RM190790 Integrity Care Group - Olive Estate Response to RFI

This is a response to your request for further information (RFI) dated 6 August 2019, on the above application for resource consent.

3.10 OPEN SPACE PLAN - OVERALL SITE

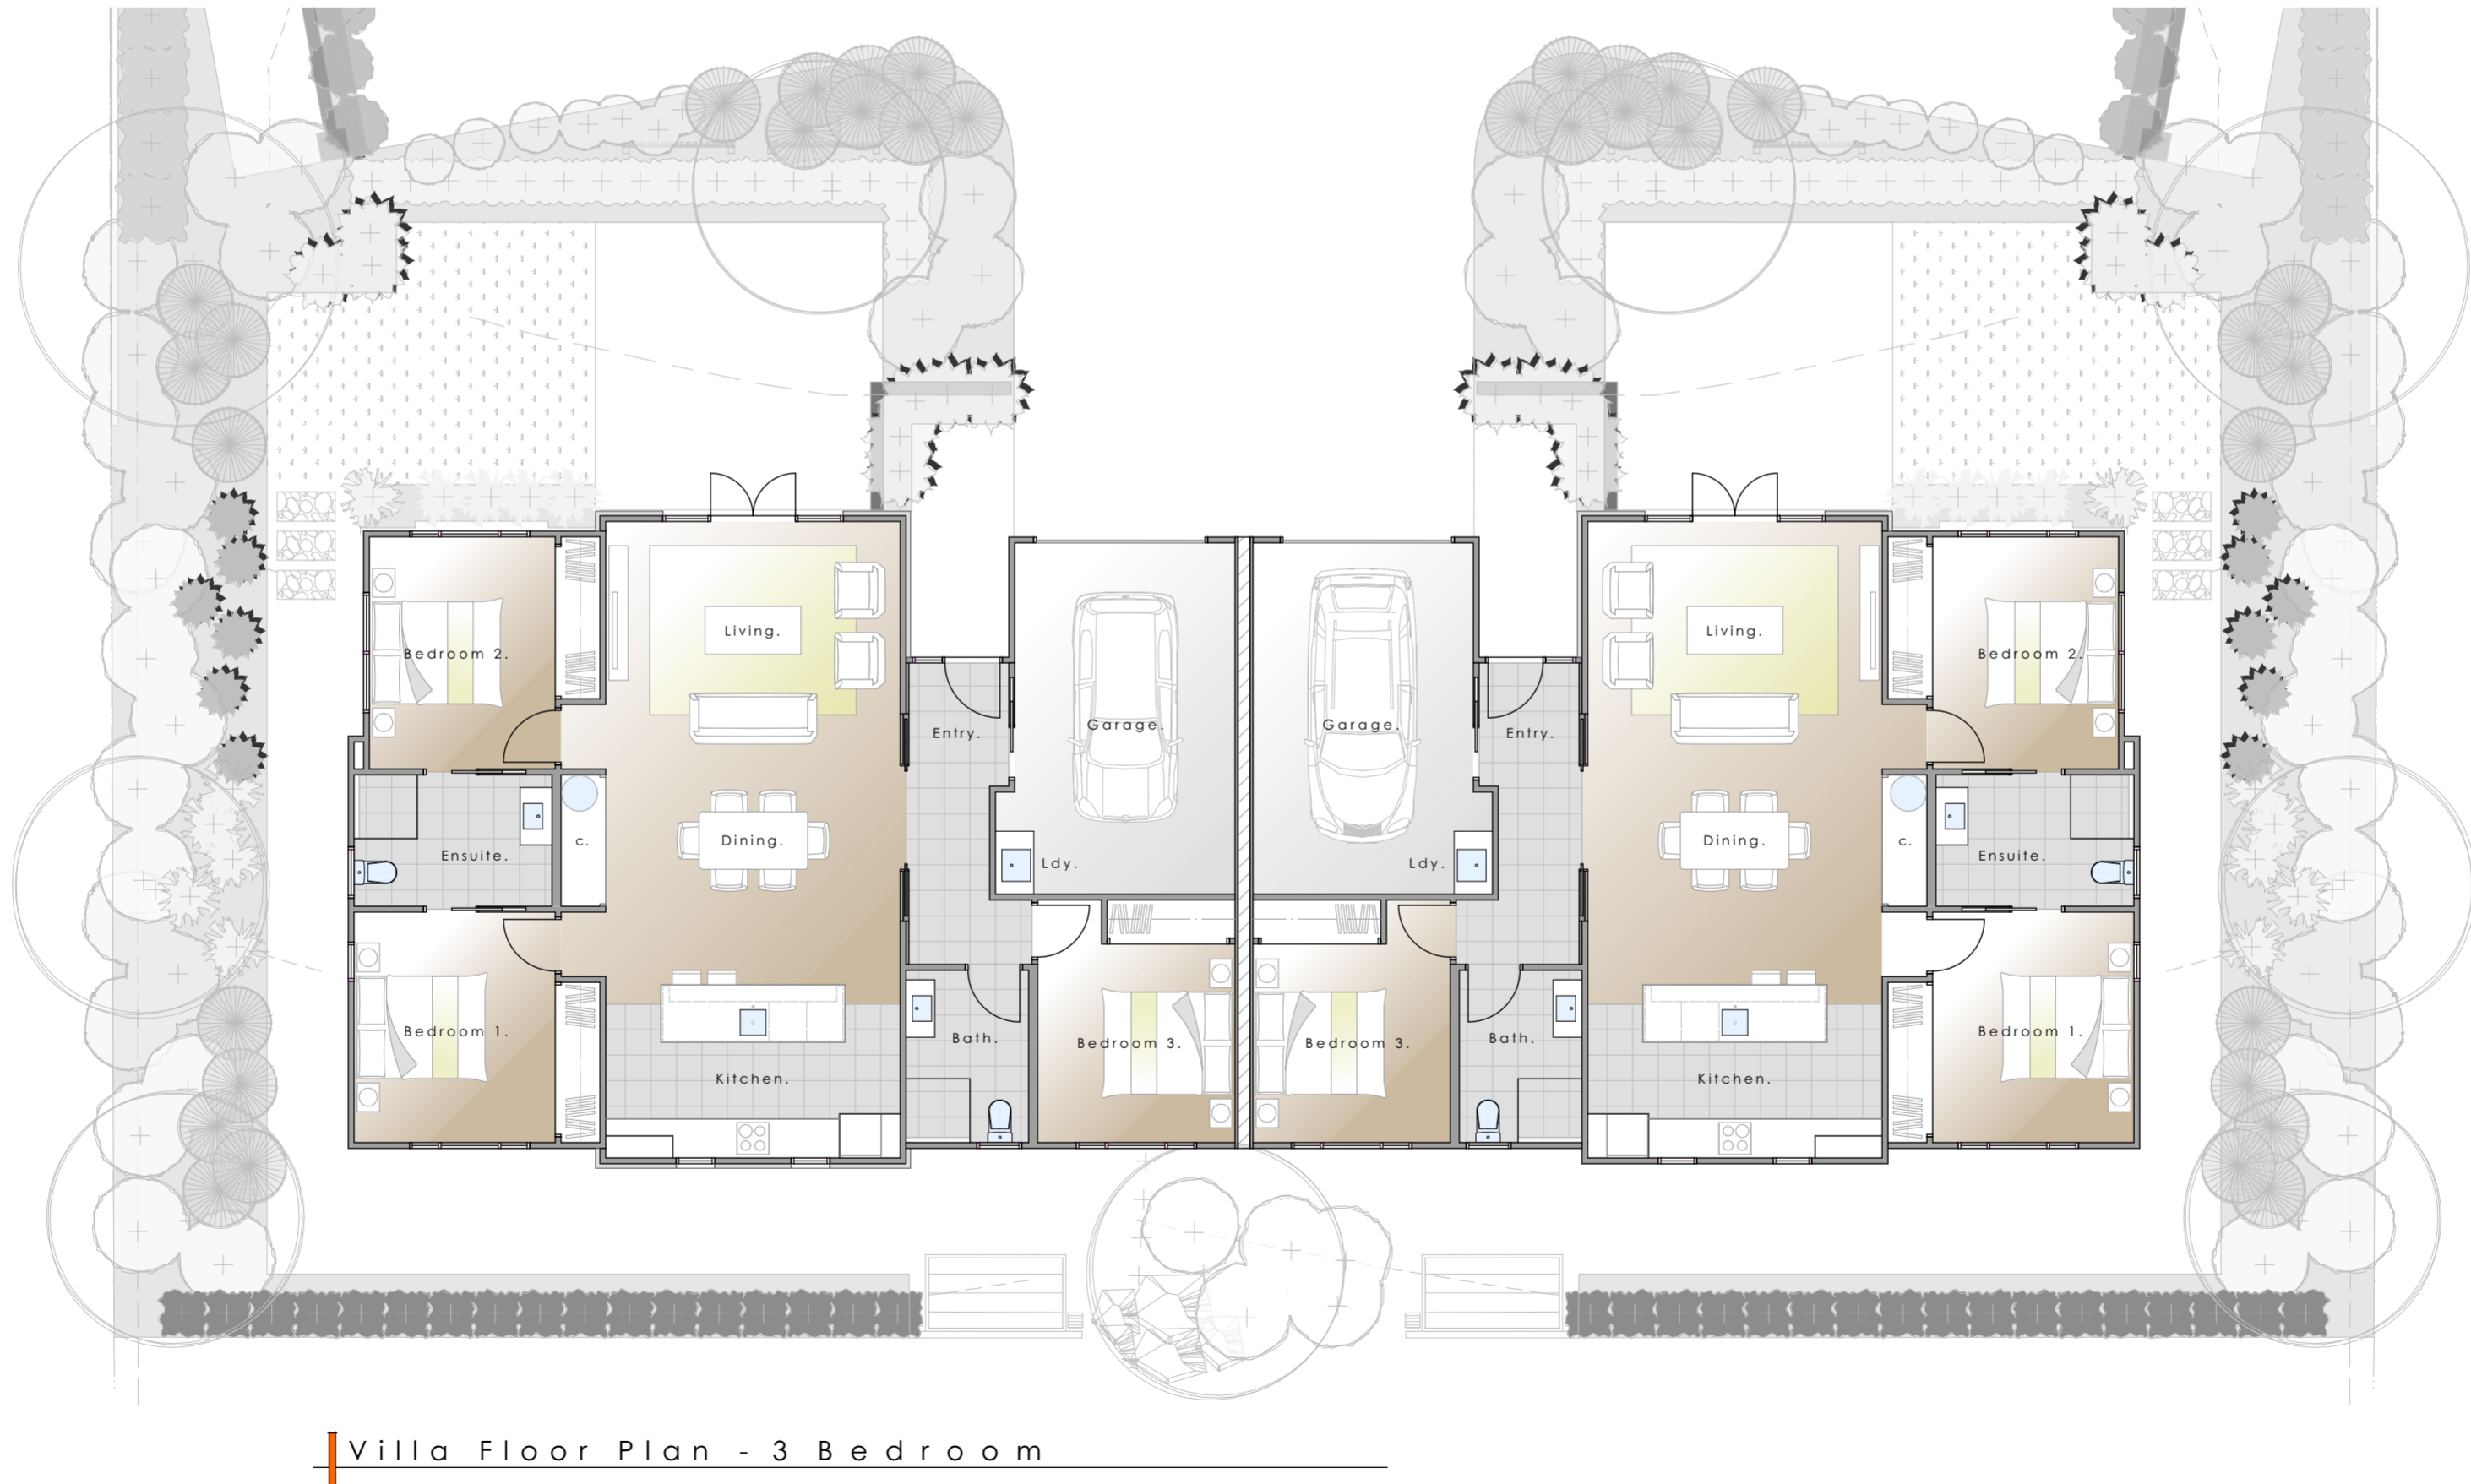
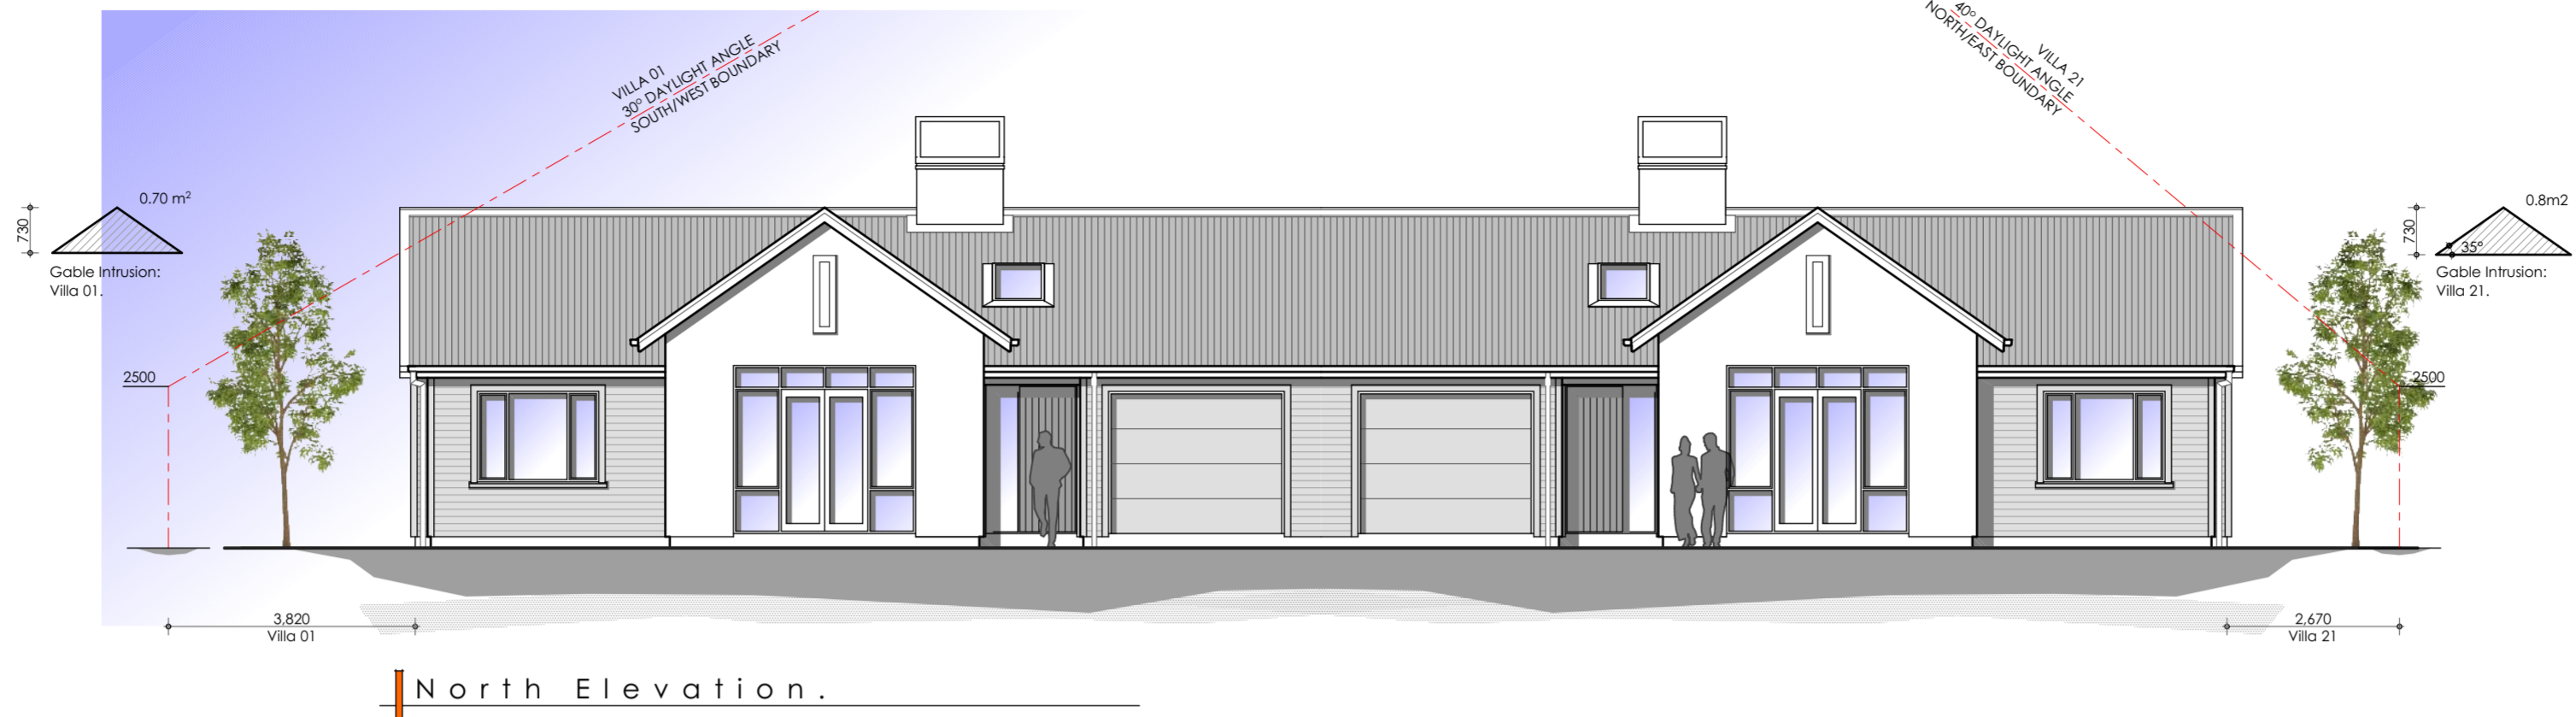
Please clarify which areas are public parks/greenways, paths and which areas are private open spaces and how any public parks will be protected for public use in perpetuity if they are not vested in Council.

Attached is a plan showing the areas the Applicant proposes to make available for public use. These areas result in a combined total of 2,500 m² of publicly available open space (refer **Attachment 3**).

Attachment 5

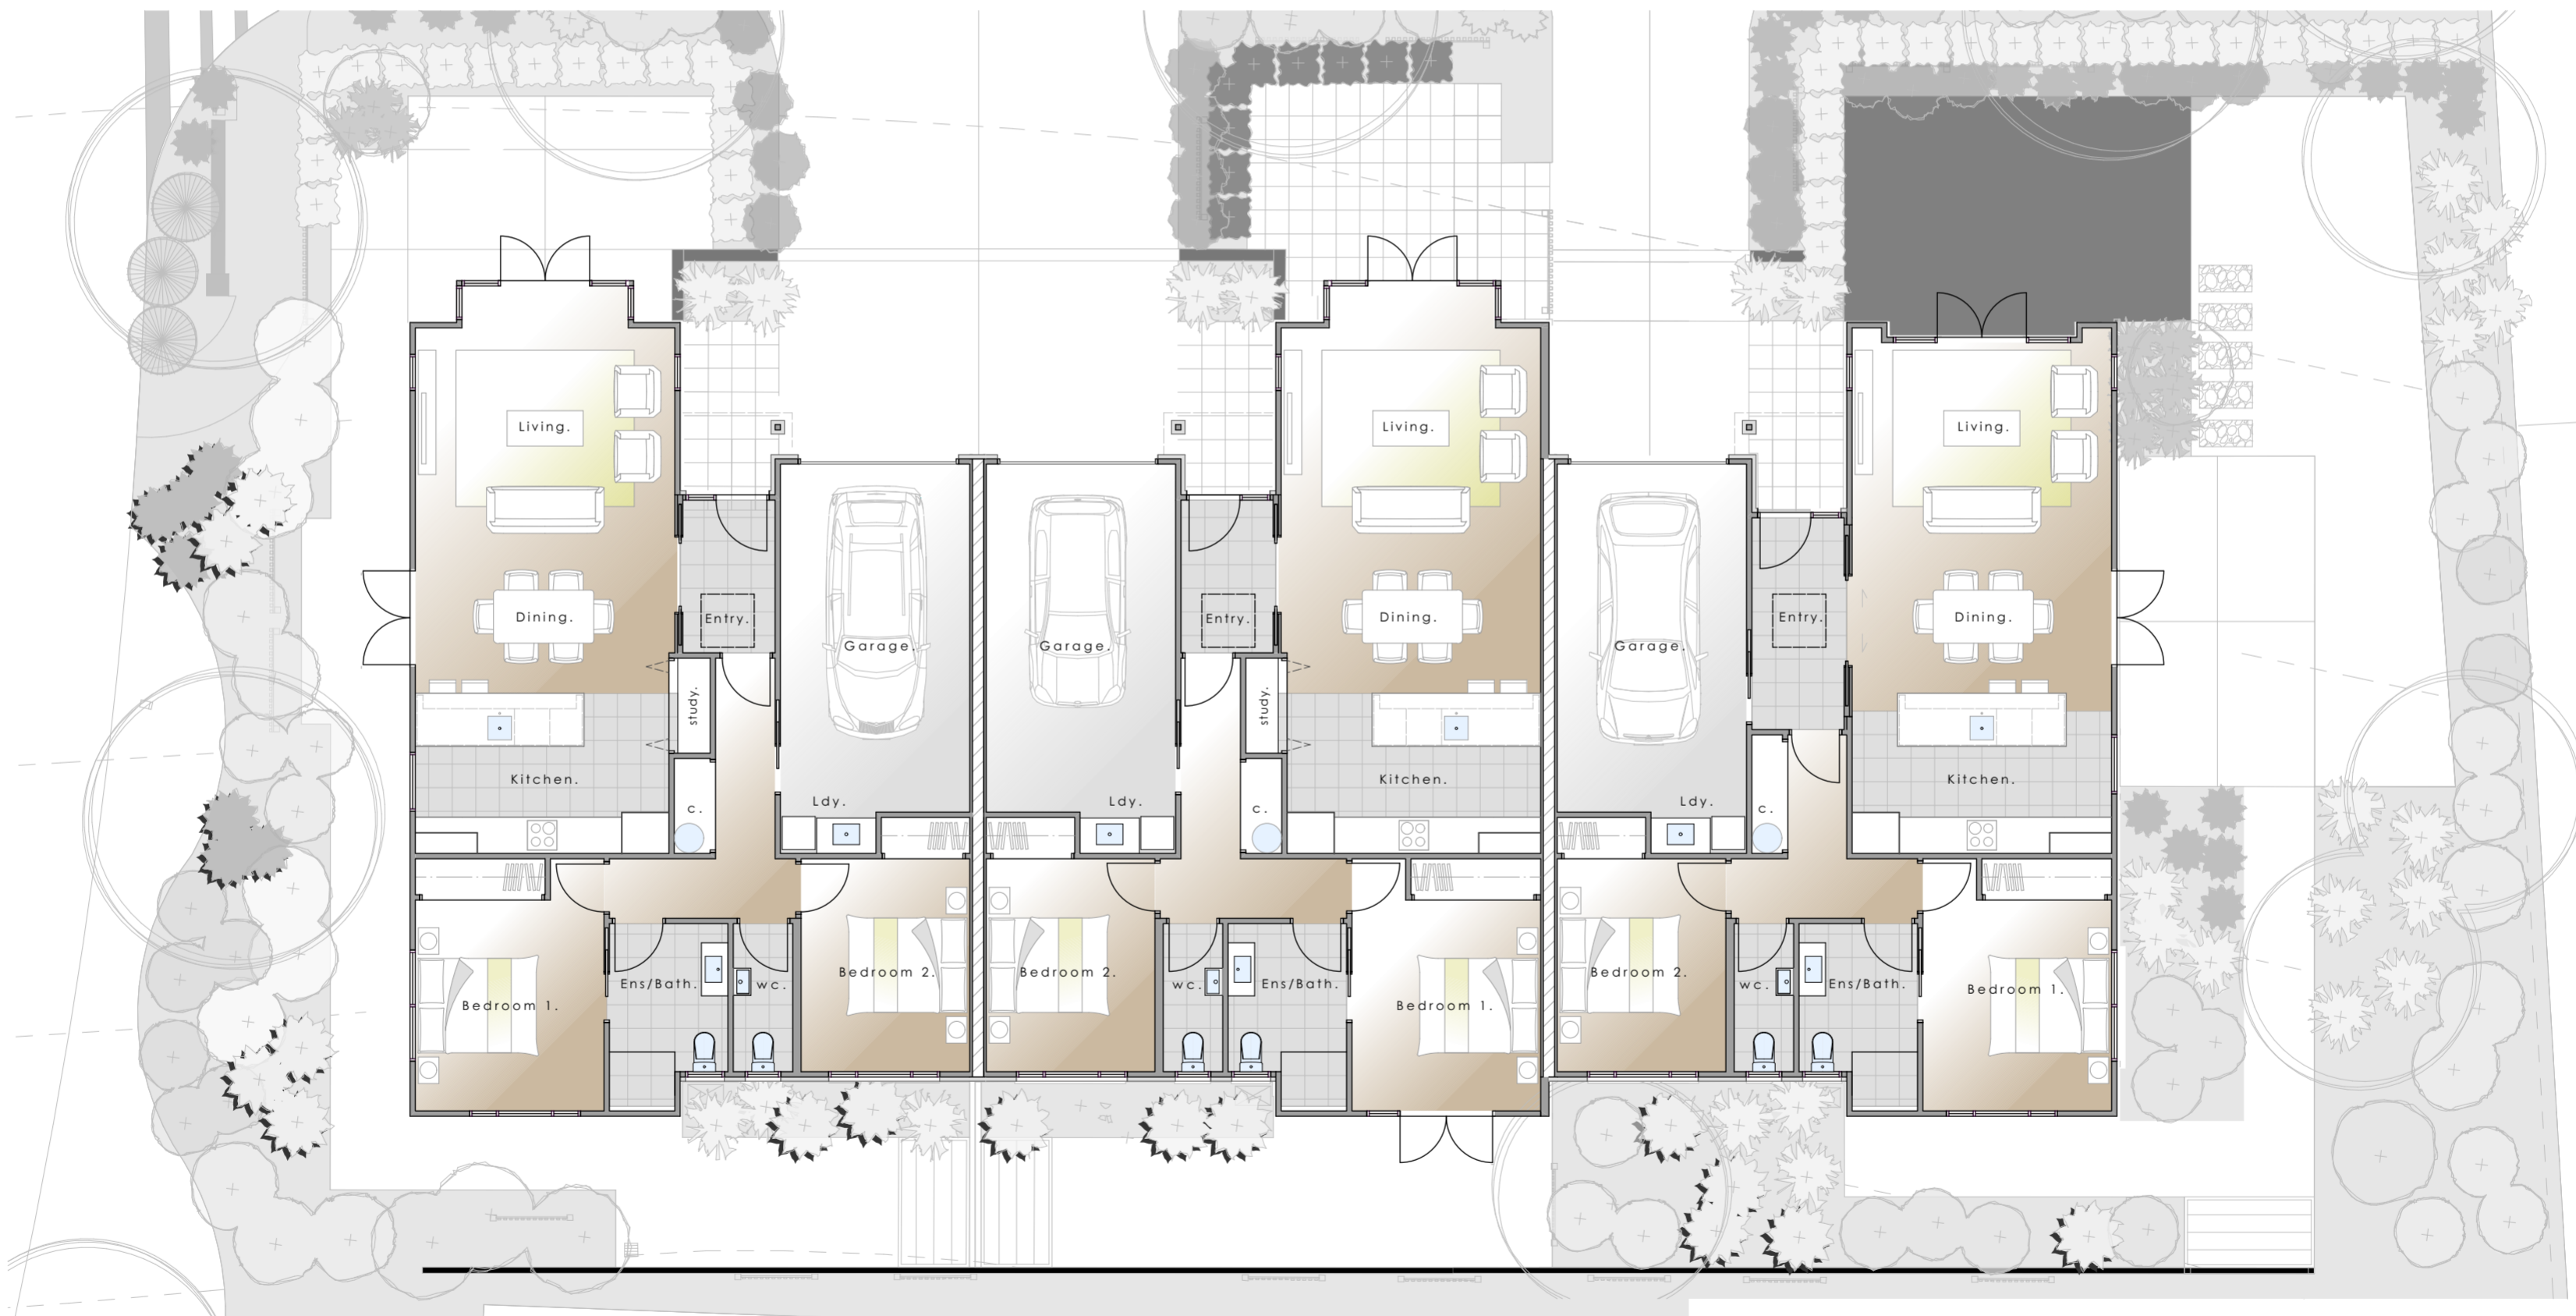
Please demonstrate compliance, or otherwise, with all set-back and daylight admission rules of the TRMP in respect of units v09, v10, v21, v22 and v25 and the boundary with the dwellings on Fawdan Way, and update the AEE as required. Particularly I note on dwg no. sk 2a (villa # 21) that the gable end of the dwelling breaches the daylight admission angle on the eastern boundary.

I can confirm that these villas, and indeed all residential dwellings, will fully comply with all set-back and daylight admission rules of the TRMP.

To confirm this, I have attached new plans sk2a and sk5a with the yard set-backs and daylight planes marked on them for Villas No.'s 21, 22 and 25 which are the buildings sited closest to the boundary stated above (refer **Attachment 5**). Those plans show complying villas, and it follows that all of the other villas which are the same height but are set back further from the boundary, are also fully complying.

Please also be aware that the Rule 17.1.1.1(n) provides: *"For any roof with a slope of 15 degrees or greater and the roof ridge generally at right angles to the boundary, the end of the ridge may be up to 1.5 metres above the indicator plane and the end area up to 2.5 square metres when viewed in elevation"*.

The gable intrusions are all within scope of the above rule, as shown in diagrammatic form on the attached plans.
